## Customer Notification

# V850ES/Fx2

## Operating Precautions

**μPD70F323x,  
μPD70323x,  
μPD70F323xA,  
μPD70323xA,  
μPD70F323xB**

Figure: Additional Measures in case AFCAN clock is active when waking up

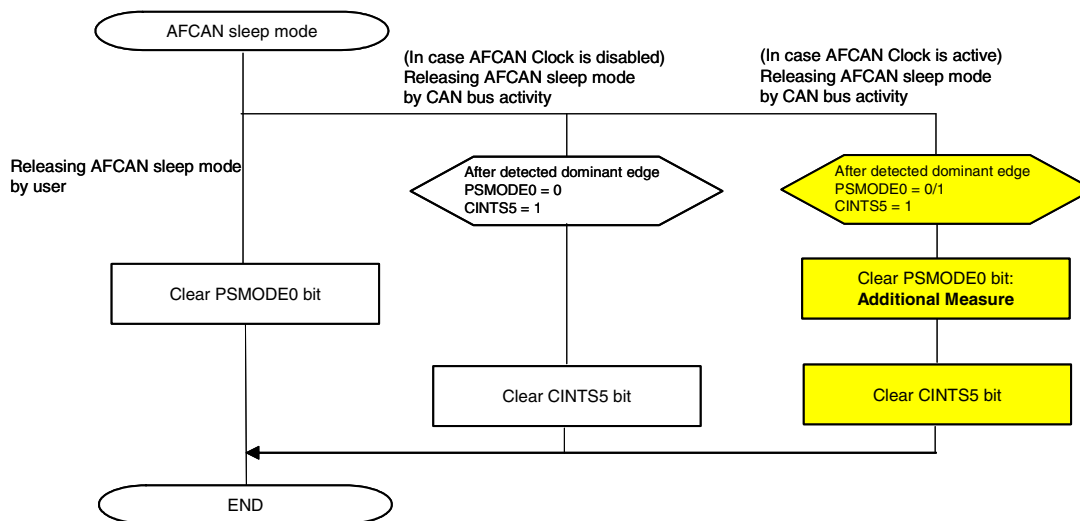
The following flowchart illustrates, how and whether additional measures have to be taken in software, to avoid the *wakeup dead time*.

No. 1	AFCAN: Sleep Mode Wakeup (Specification change notice)
<p><u>3.3 Affected Applications</u></p> <p><u>3.3.1 Applications not waiting until SLEEP mode is left</u></p> <p>If bus transceivers are used in conjunction with AFCAN, which will propagate the CAN bus signal to AFCAN permanently (not switched off or not in power saving modes), or, if bus transceivers are used in conjunction with AFCAN, which will propagate the unmodified CAN-Bus signal when waking up from a power save mode, the wakeup dead time lasts from the first recessive-to-dominant edge of the CAN-Bus signal, which generates the wake-up, until the next recessive-to-dominant edge of the CAN-Bus signal.</p> <p>The worst case (maximum length) of the wakeup dead time, is given by the CAN bus speed and the rule of the CAN bus about the frequency of recessive-to-dominant edges. Given by the stuffing rule, at least every 10 bits, a recessive-to-dominant edge must occur.</p> <p>If during the wakeup dead time, the CPU waits until the SLEEP mode is indicated to be cleared (either by polling the PSMODE flag, or by retrying to clear CnINTS[5]), <b>this operating precaution is not applicable</b>. In this case, the improvement hint according to 4.2.2 is followed implicitly. If during the wakeup dead time, the CPU does not perform any access to the AFCAN macro in any case, <b>this operating precaution is not applicable</b>.</p> <p><u>3.3.2 Applications using Bus Transceivers generating long-lasting dominant CAN-Bus Signals</u></p> <p>If bus transceivers are used in conjunction with AFCAN, which <i>generate a permanent or long-lasting dominant level</i> when waking up from a power save mode, the operating precaution must be considered in any case.</p> <p>In this case, the wakeup dead time lasts from the first recessive-to-dominant edge of the CAN bus signal, which generates the wake-up, until the next recessive-to-dominant edge of the CAN bus signal, depending on the behaviour of the CAN bus transceiver.</p> <p>If no further dominant edge on the CAN bus occurs (in case of some CAN transceivers, which only provide one single edge on waking up), the time until SLEEP mode is left may become endless. Therefore, the waking up procedure of AFCAN regarding software, must be adjusted according to 4.1.1.</p> <p><u>4. Software Improvement Hints</u></p> <p><u>4.1 Recommended WAKEUP Handling by Software</u></p> <p><u>4.1.1 Clearing the SLEEP Mode by Software</u></p> <p>Within the WAKEUP interrupt routine, before accessing any other register or area of AFCAN, the SLEEP mode can be canceled by software, followed by a clearance of the WAKEUP interrupt flag.</p> <p>Doing so, the AFCAN macro will start its synchronous operation right after these accesses.</p> <p>In the following C-code example, replace the objects in "&lt;&gt;" brackets by the hardware locations within your implementation. Use the appropriate access types, as described in the User's Manual.</p> <pre> WAKEUP INTERRUPT VECTOR --&gt;                                 &lt;CnCTRL_PSMODE&gt; = 0;    /* Clear SLEEP Mode */                                 &lt;CnINTS_CINTS5&gt; = 1;    /* Clear INTS5    */                                 ...                                 /* following other parts of interrupt routine */                                 ... </pre> <p><b>Remark:</b> Clearing INTS5 is required to get another WAKEUP interrupt anyway, by specification.</p>

No. 1	AFCAN: Sleep Mode Wakeup (Specification change notice)
<p><u>4.2 Other WAKEUP Handling Hints</u></p> <p><u>4.2.1 Switching off the Clock Supply to AFCAN, while in SLEEP Mode</u></p> <p>If the clock supply to the AFCAN macro is stopped, while it is in SLEEP mode, the synchronisation of the WAKEUP works without any restriction. To achieve this, the documentation of clock controlling unit of the target device should be consulted. Usually this is performed by setting the STOP mode of the CPU of the target device.</p> <p>However, the user has to consider, that there must not be any WAKEUP condition (dominant level on the CAN-Bus), while the software is executing between setting SLEEP mode and stopping the AFCAN clock.</p> <p><u>4.2.2 Using a Waiting Loop within the WAKEUP interrupt routine</u></p> <p>Within the WAKEUP interrupt routine, create a waiting loop, which tests the capability of clearing the WAKEUP interrupt flag within AFCAN, by checking the actual power save mode.</p> <p>In the following C-code example, replace the objects in "&lt;&gt;" brackets by the hardware locations within your implementation. Use the appropriate access types, as described in the User's Manual.</p> <pre> do {     AFCAN_SleepStatus = &lt;CnCTRL_PSMODE&gt;      if( AFCAN_SleepStatus != 0 )     {         /* macro is still in SLEEP mode (waiting for latency time) */         &lt;CnINTS_CINTS5&gt; = 1; /* repeated trying to clear CINTS5 */     }  } while( AFCAN_SleepStatus != 0 ); </pre> <p>This improvement hint <b>cannot be applied</b>, if a CAN-Bus-Transceiver is attached to AFCAN, which generates a permanent or long-lasting dominant level to the FCRXDn receive input pin, if a wakeup condition occurs. Missing another dominant edge on the bus, the synchronisation will not happen, and the loop could run endlessly.</p> <p><u>4.2.3 Using INIT Mode instead of SLEEP Mode</u></p> <p>In this case, the waking up by CAN-bus activity must be performed via another free external interrupt. The CAN receive signal must be distributed on the FCRXDn pin, and to another external interrupt pin in parallel.</p> <p>Using this external interrupt, the AFCAN macro can be restored into the previous operation mode. This implementation will not use the SLEEP mode of AFCAN at all, and use the INIT mode instead.</p>

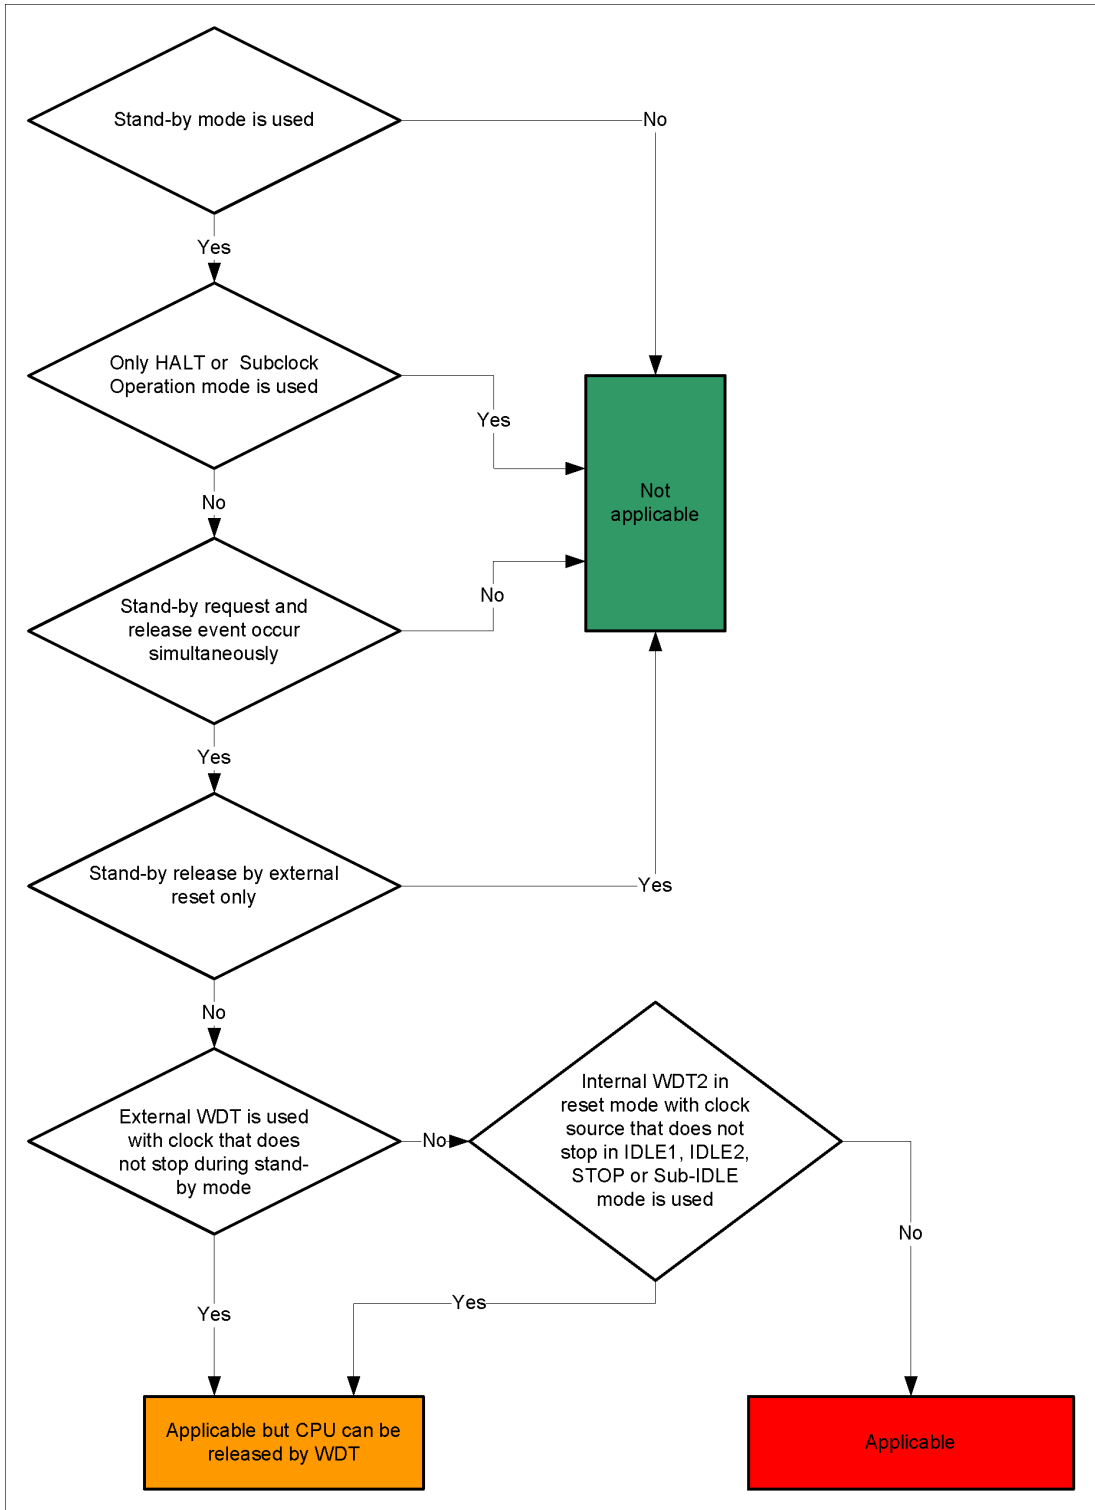
No. 2	Stand-by Mode Release (Specification change notice)
<p><u>Description:</u> If a stand-by mode request and a wake-up event coincide with the same timing, the <math>\mu</math>C may enter the power save mode in a way that the power save mode can be released by Reset (external or internal) only. This happens only if the stand-by mode request and the wake-up event occur within a timing window of 0.46 nsec width.</p> <p>The term "stand-by mode" of the above description refers to all stand-by modes which are selected by the Power Save Control Register (PSC). The term "wake-up event" of the above description refers to any event which is configured to release the microcontroller from a stand-by mode. This can be any unmaskable or unmasked maskable interrupt (internal or external) except reset.</p> <p>Affected stand-by modes are:</p> <ul style="list-style-type: none"><li>- Idle1 Mode,</li><li>- Idle2 Mode,</li><li>- Sub-Idle Mode and</li><li>- Stop Mode</li></ul> <p>Not affected stand-by mode:</p> <ul style="list-style-type: none"><li>- Halt Mode</li></ul> <p>Please see the flowchart on the following page.</p>

Description (continued):

Please see the following flowchart to check if the described behaviour might be relevant for a particular application:
